Addendum to IFB

IFB NUMBER: IFB 24-062/MR
IFB TITLE: Jefferson County Diversion Center Renovation
IFB DUE BY: 11:00 am CT, Wednesday, November 13, 2024
ADDENDUM NO.: 1
ISSUED (DATE): November 1, 2024

ADDENDUM # 01

IFB 24-062/MR Jefferson County Diversion Center Renovation

DEMOLITION PLAN

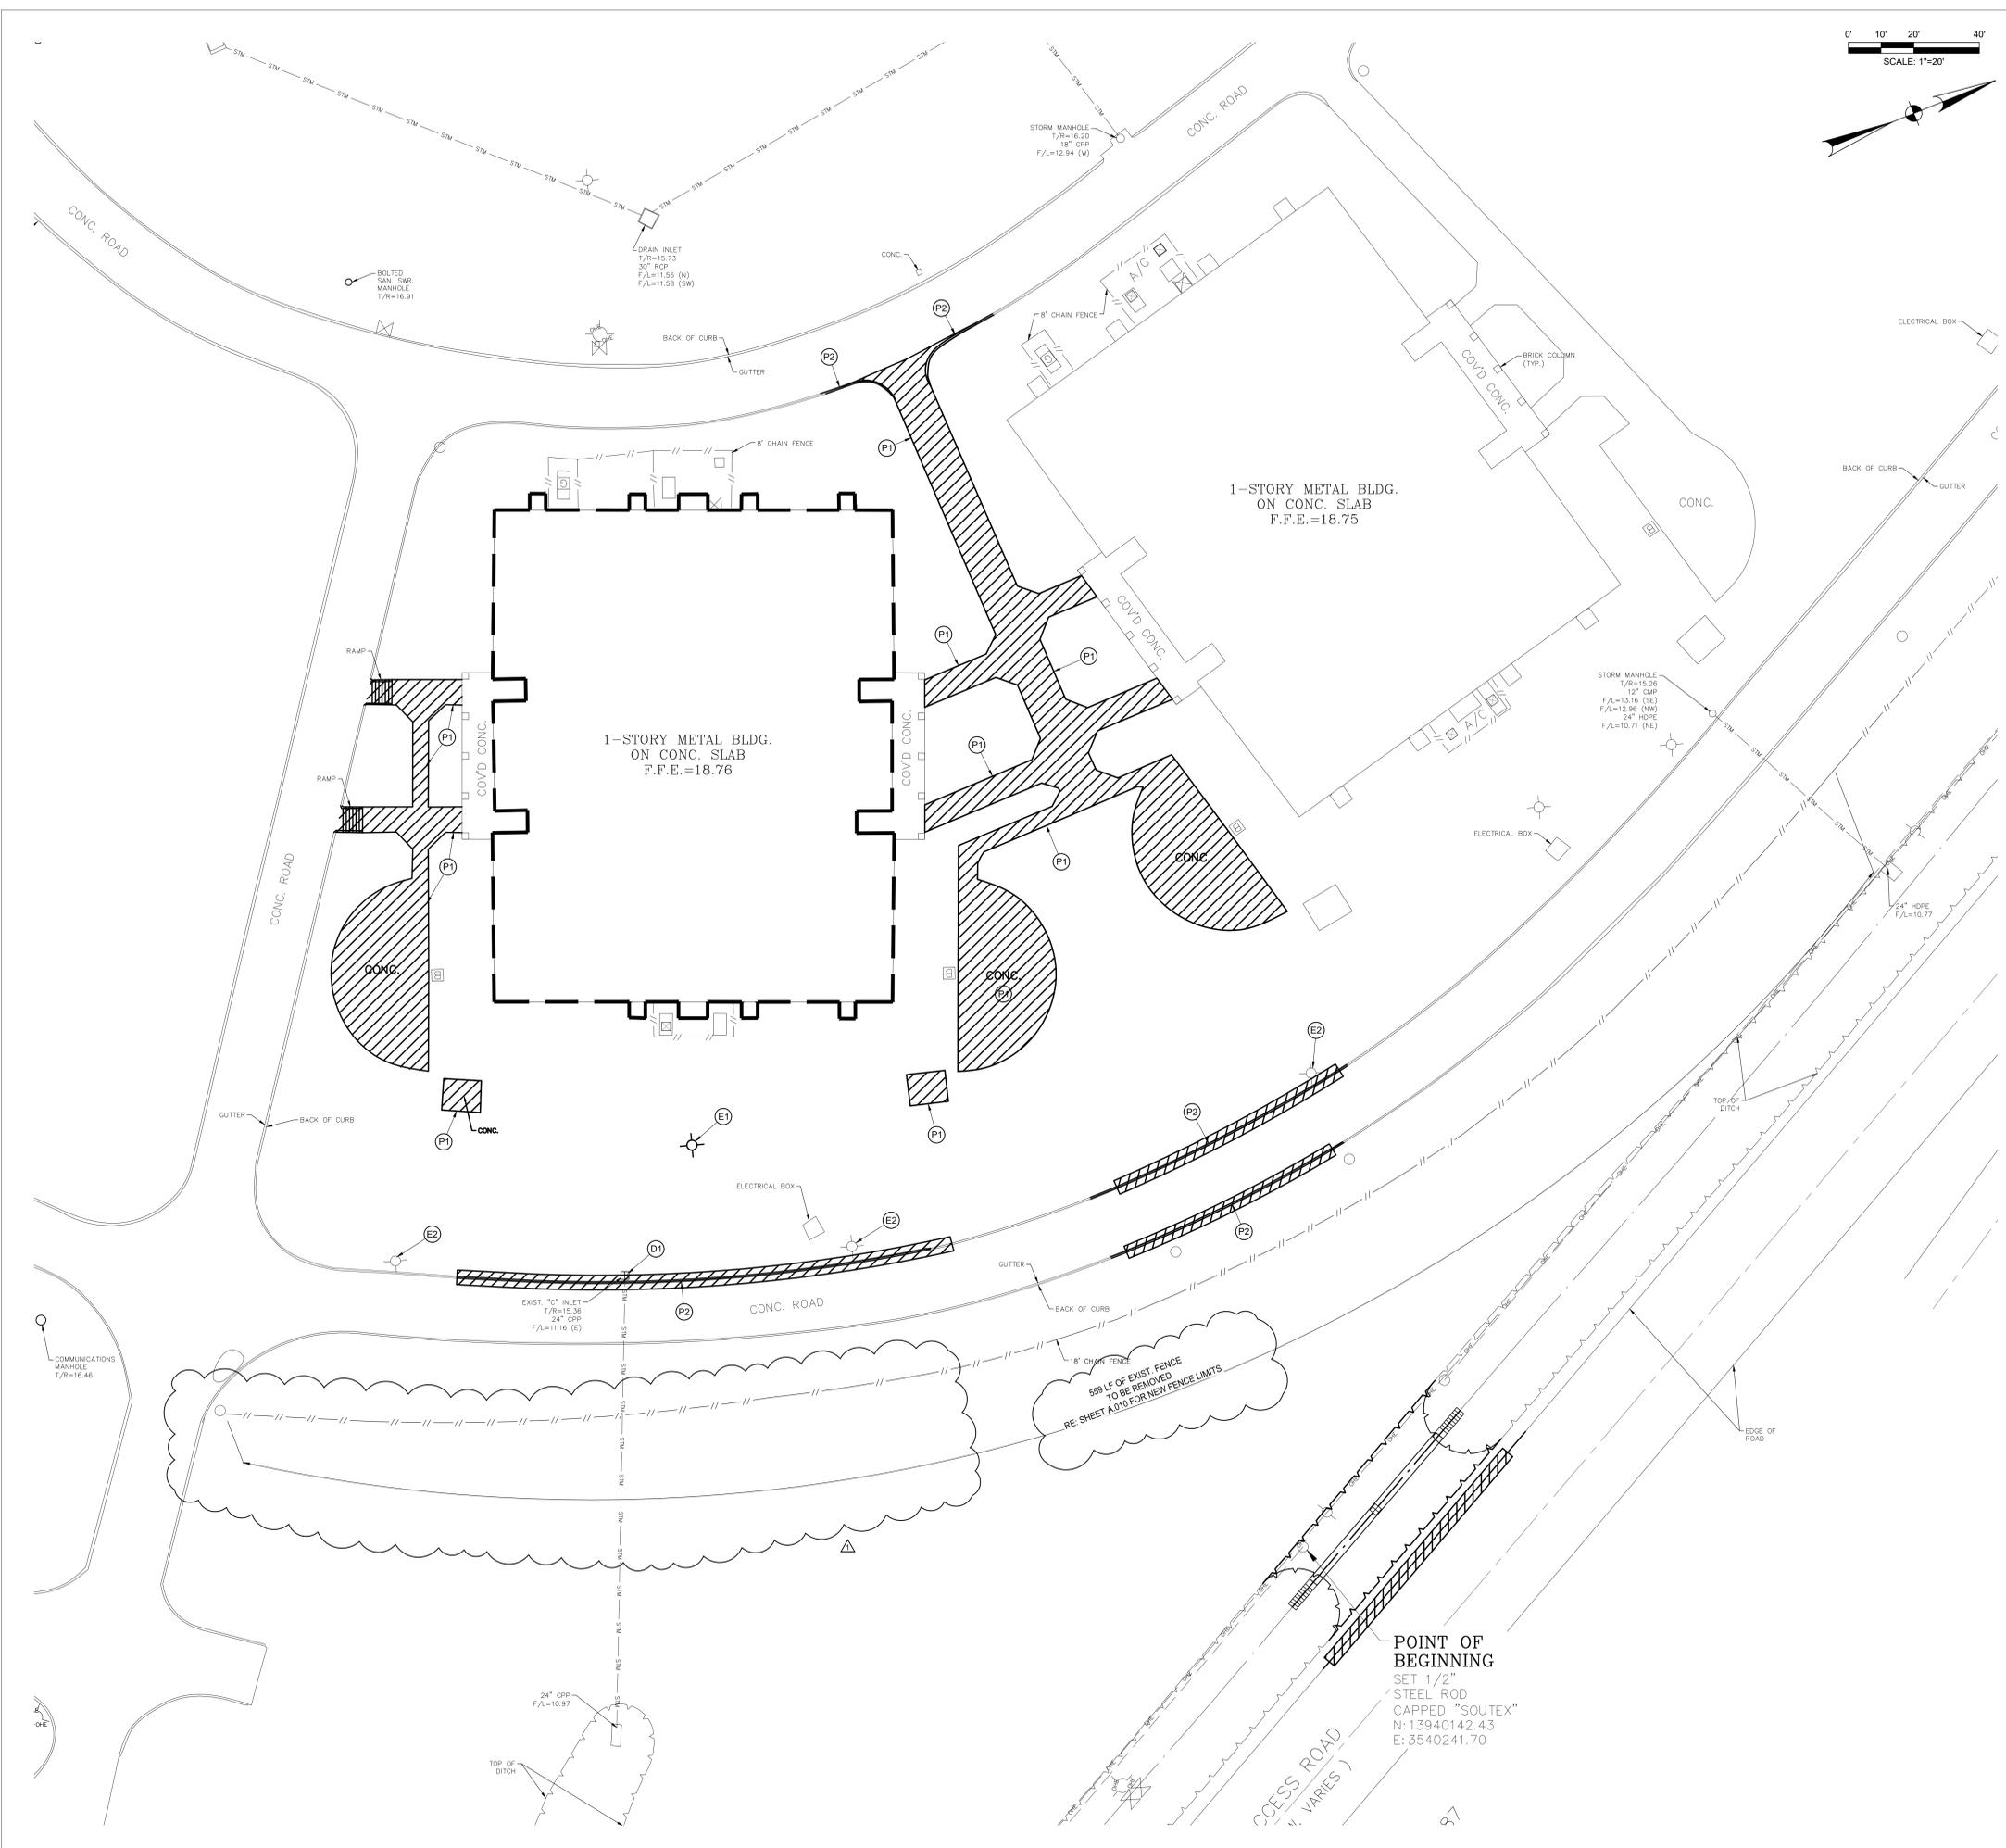
Extended fence demo limits and referenced sheet A.010.

559 LF OF EXIST. FENCE TO BE REMOVED RE: SHEET A/D IN FOR NEW FENCE LIMITS

DEMOLITION - OVERALL
FLOOR PLAN

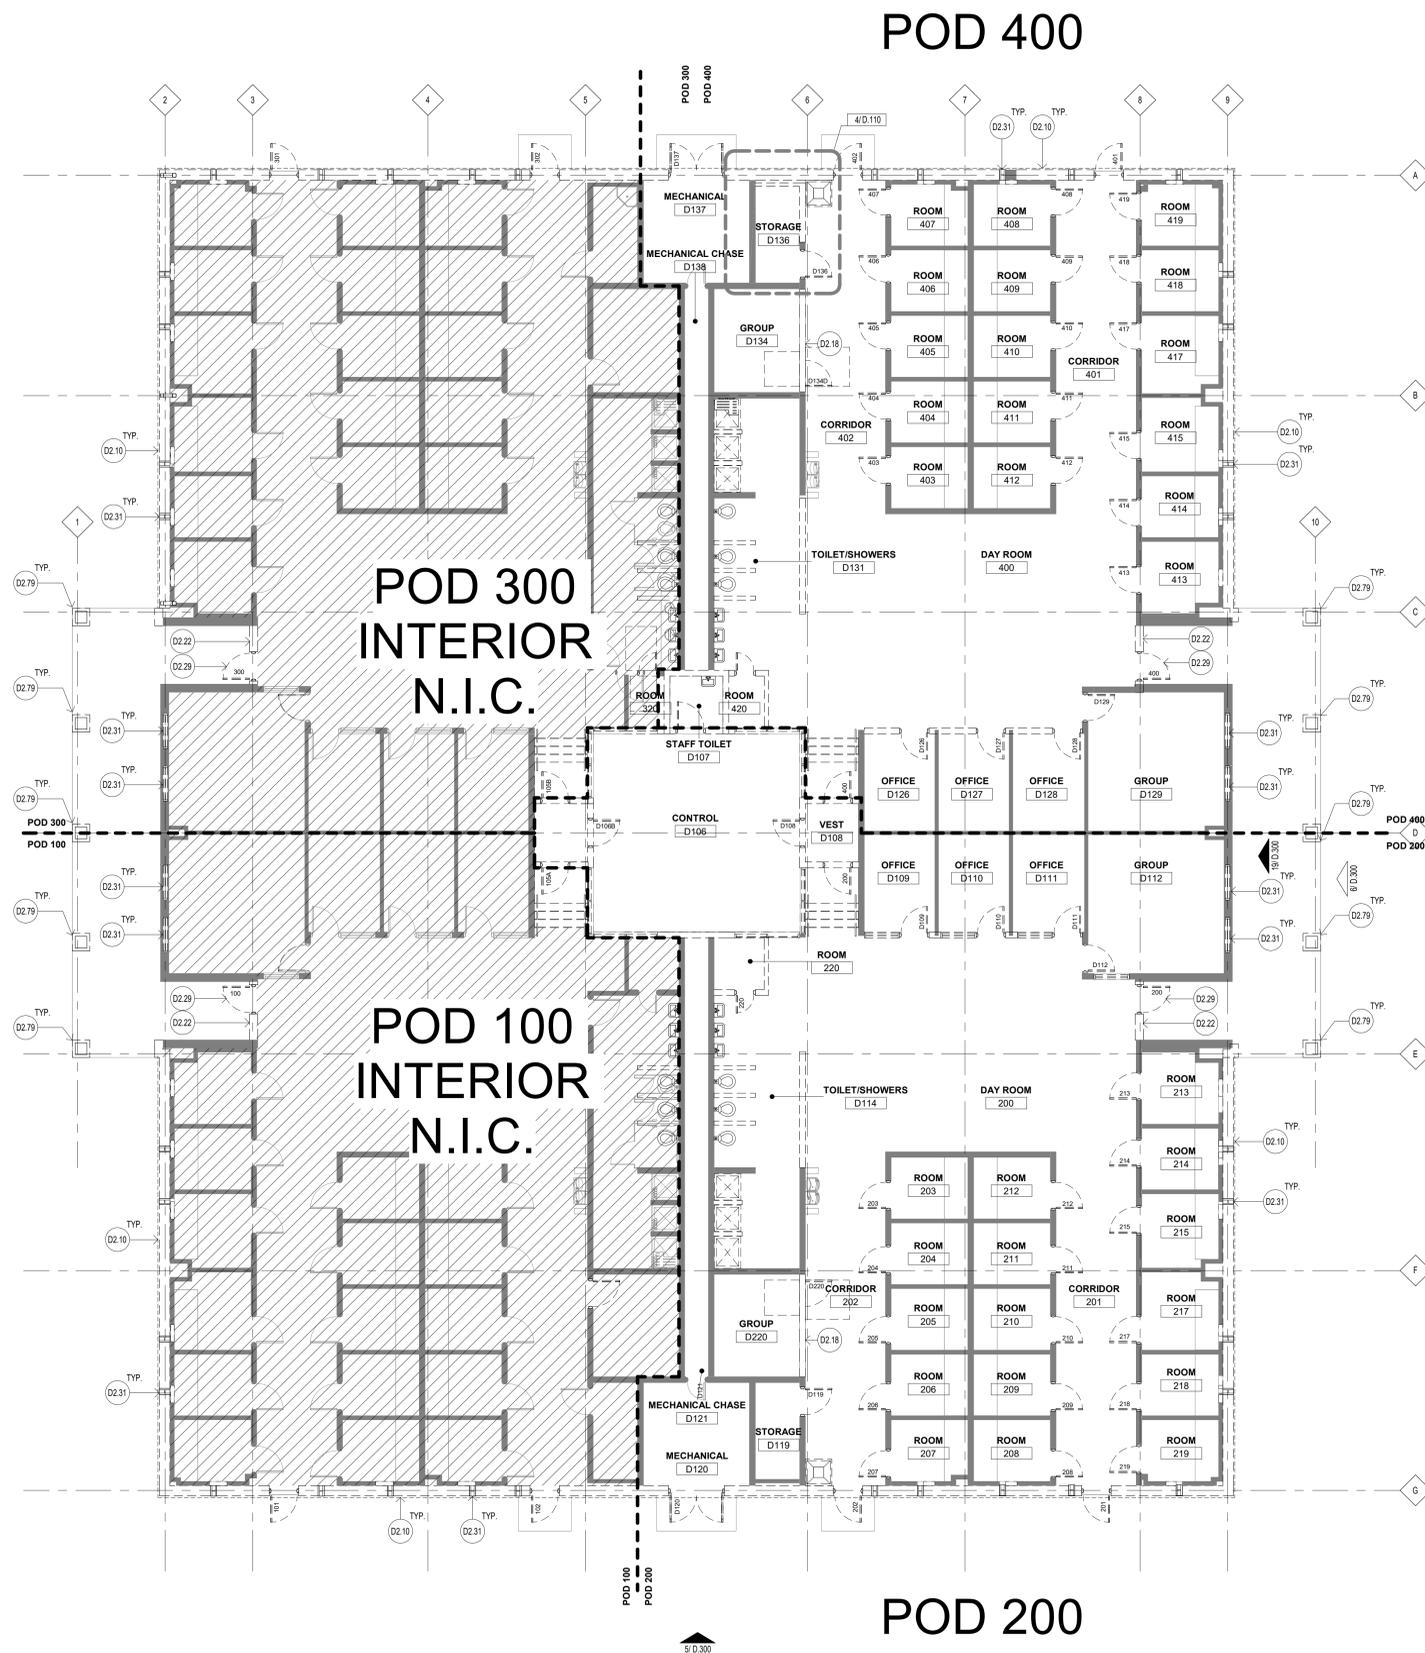
MODIFIED DEMOLITION SCOPE OF WORK

Mold Remediation demolition scope has been modified, so Demolition required by GC has been reduced. Listed below are items allocated to demolition vs Remediation GC. Sheet notes on D.101, D.110, D.111, D.121 and D.125 revised.

- a) All interior Door Frames to be demolished as shown in the drawings.
- b) All exterior doors and frames to be demolished as shown in the drawings.
- c) All CMU wall and interior dry wall to be demolished as shown in the drawings.
- d) Existing overhead removed by renovation contractor may leave holes in the wall of the mechanical room/mezzanine floor or other spaces that needs to be patched and repaired.
- e) Exterior soffits at entry canopy and exterior walls to be demolished as show in the drawings.
- f) Existing roof patching at roofed locations to be repaired and patched as noted in the drawings.

DEMOLITION - ENLARGED FLOOR PLAN POD 200

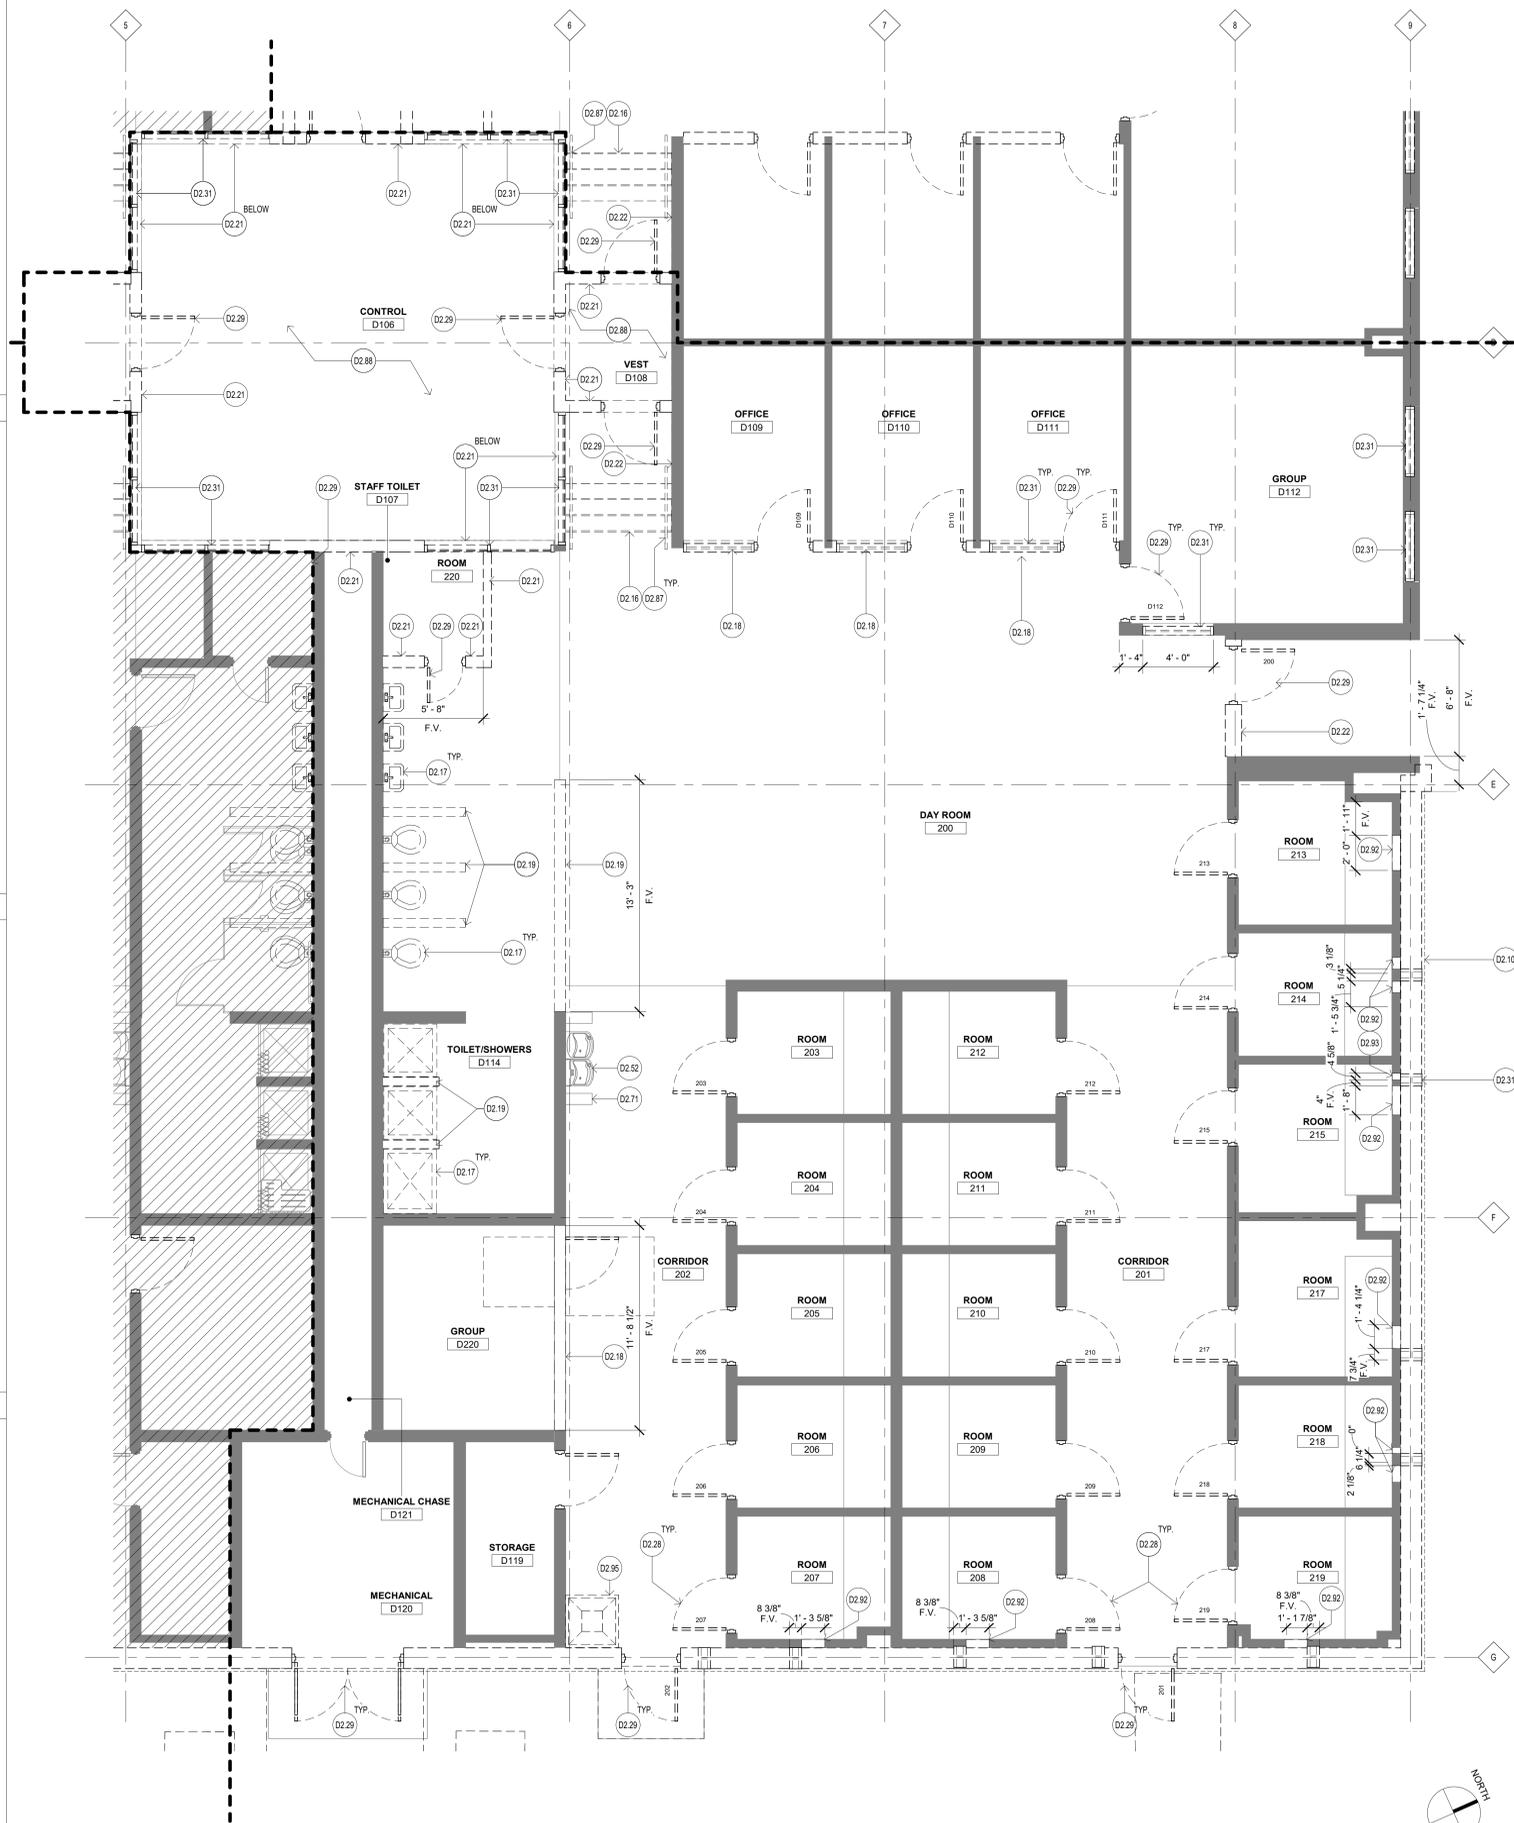
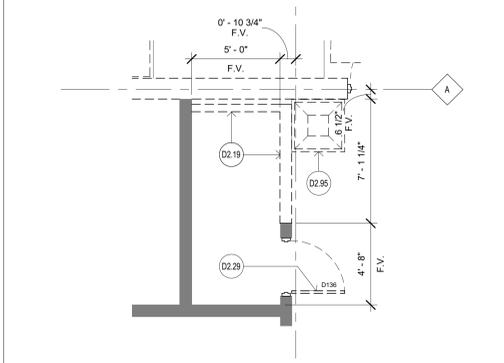
MODIFIED DEMOLITION SCOPE OF WORK
Mold Remediation demolition scope has been modified, so Demolition required by GC has been reduced. Listed below are items allocated to remediation vs Renovation GC.

EXTERIOR GLAZING & DOOR DETAILS

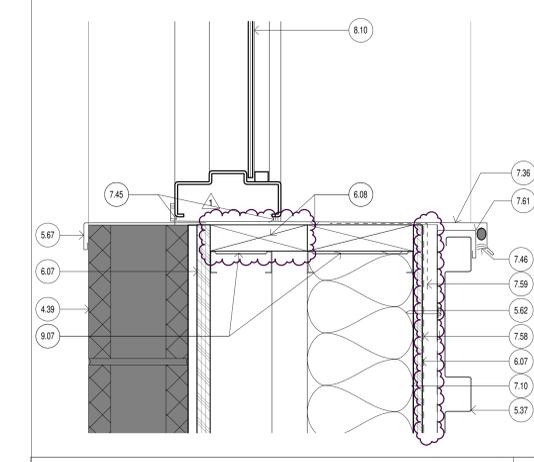
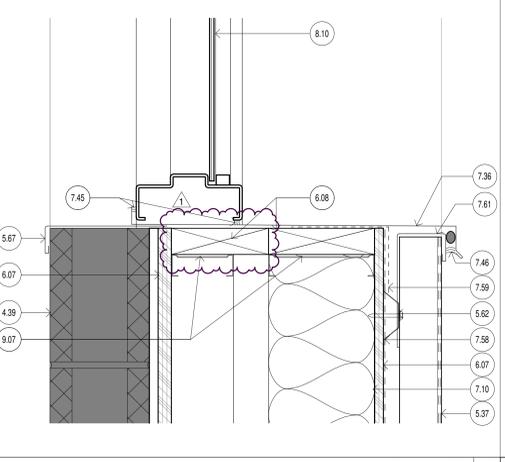
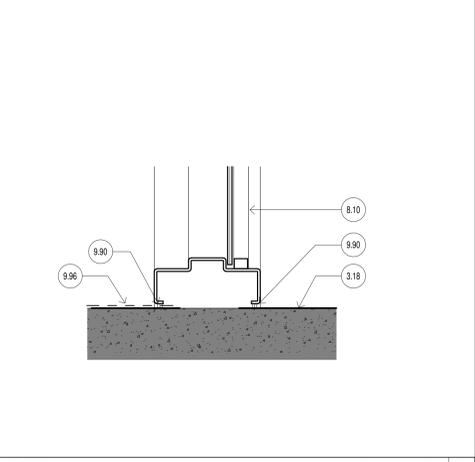
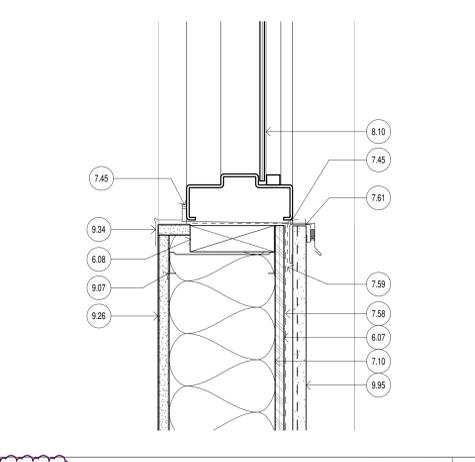
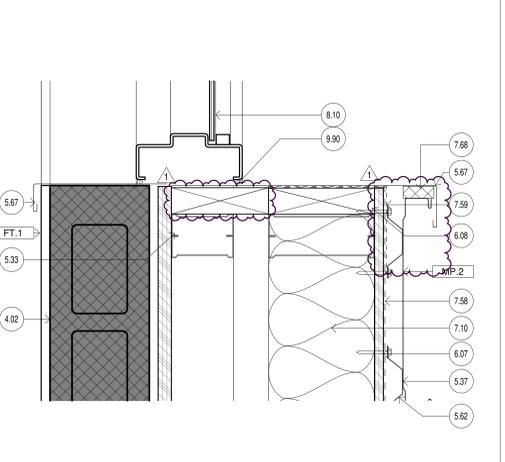
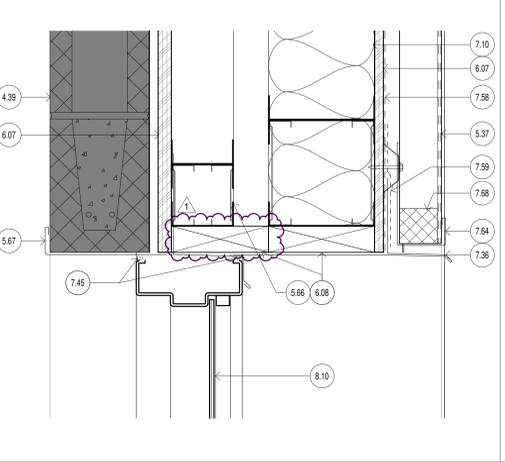
Sheet A.611 Exterior Glazing & Door Details

1. Flexible Flashing to be provided at all windows. Seal top edge of flexible flashing
2. Casing Bead renamed to form
3. Hat channel provided to support metal panels
4. Form-Closure shown at all Metal panel ends. typical detail.
5. Wood blocking extended to the width of the wall at all windows. typical detail.
